ACCESS REPORT

Reference Number: 26088

Client: LAVISS PTY LTD

Site Address: 20-24 Parmal Ave, Padstow

[Image description: Plan of Basement Level above shows the provision of Accessible parking spaces]

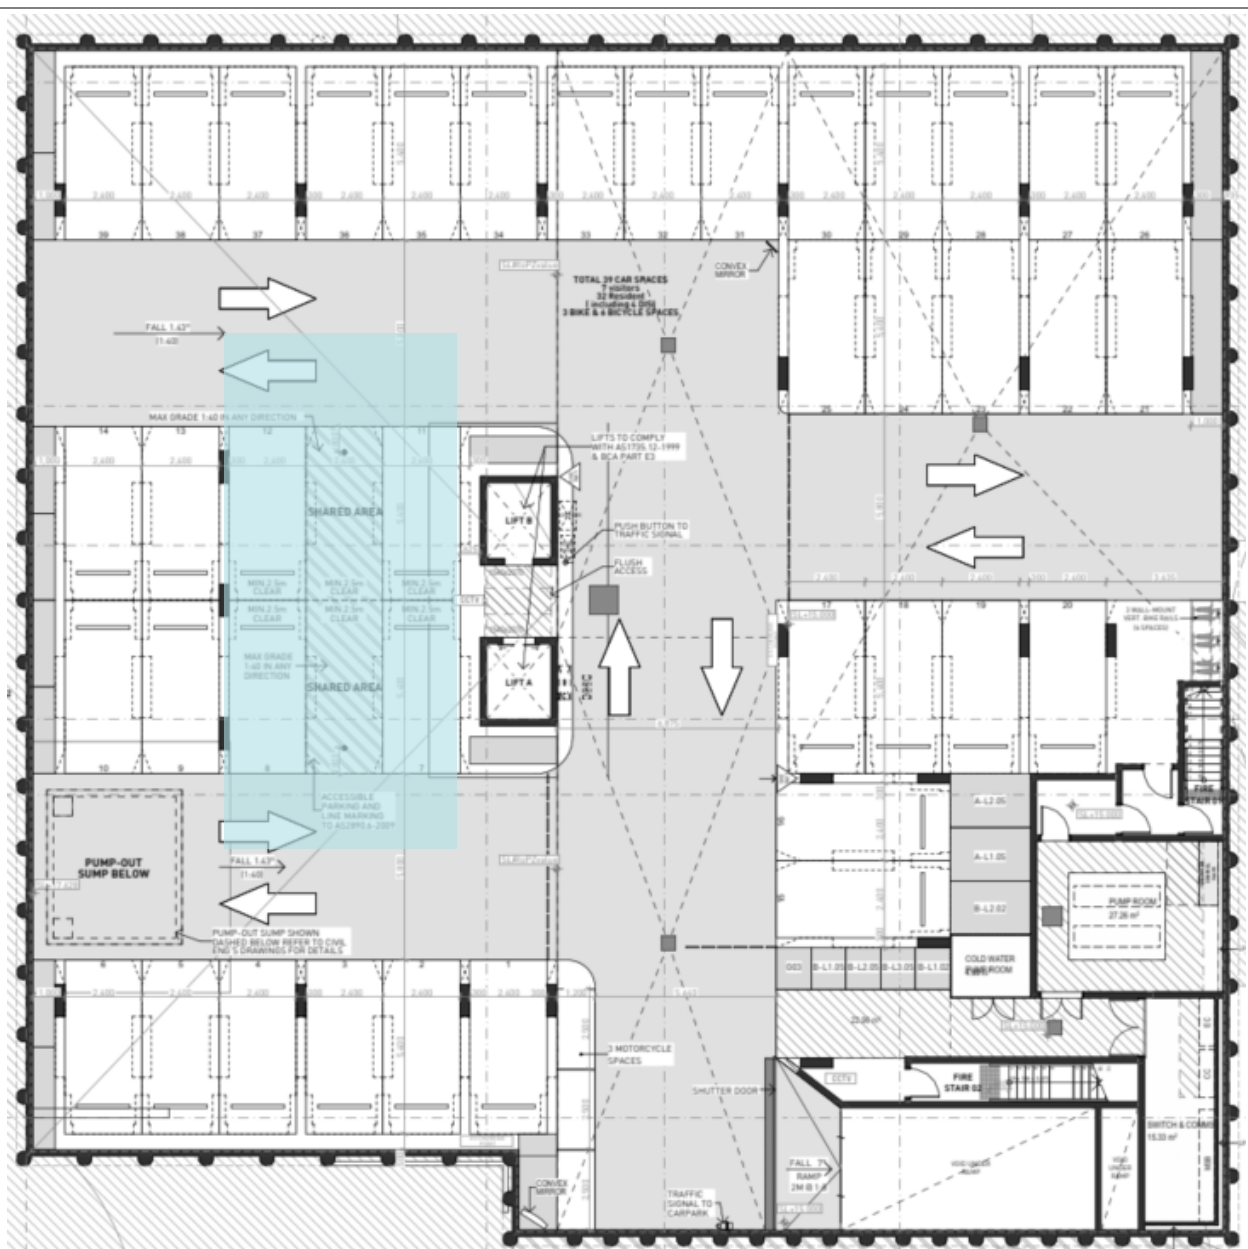
Canterbury-Banks town council has no requirement for Adaptable Units

Therefore, 04 Accessible compliant car parking spaces have been provided in development.

One accessible compliant parking space is required to be allocated to either visitor or to LHA Gold level units

[Image description: Diagram showing spatial requirements of AS2890.6-2009 including line marking and bollard requirements]

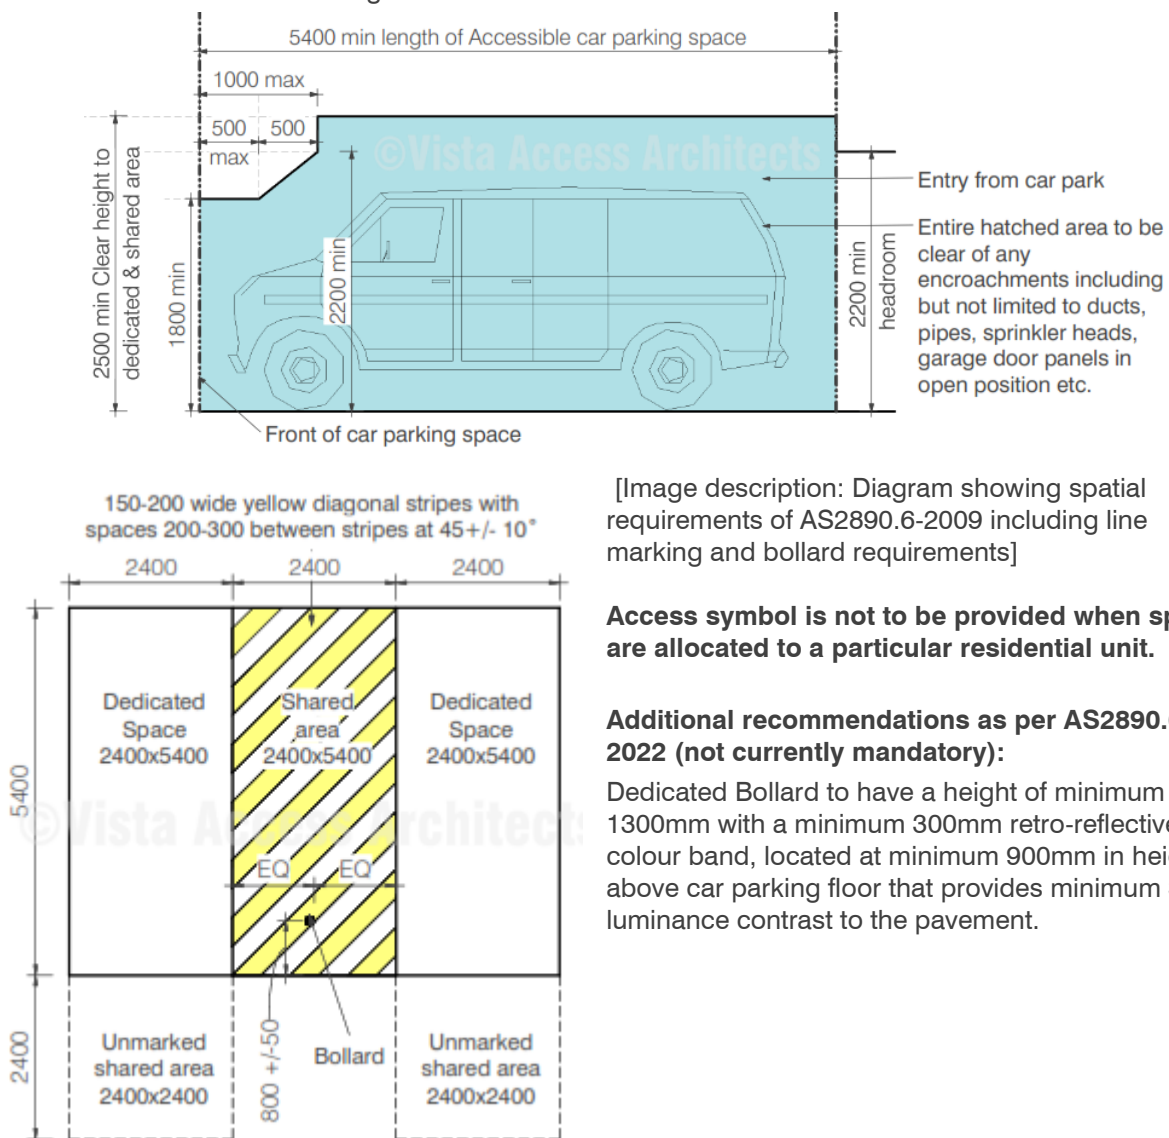
Ensure max grade of 1:40 in any direction in shared zone and Accessible parking

Access symbol is not to be provided when spaces are allocated to a particular residential unit.
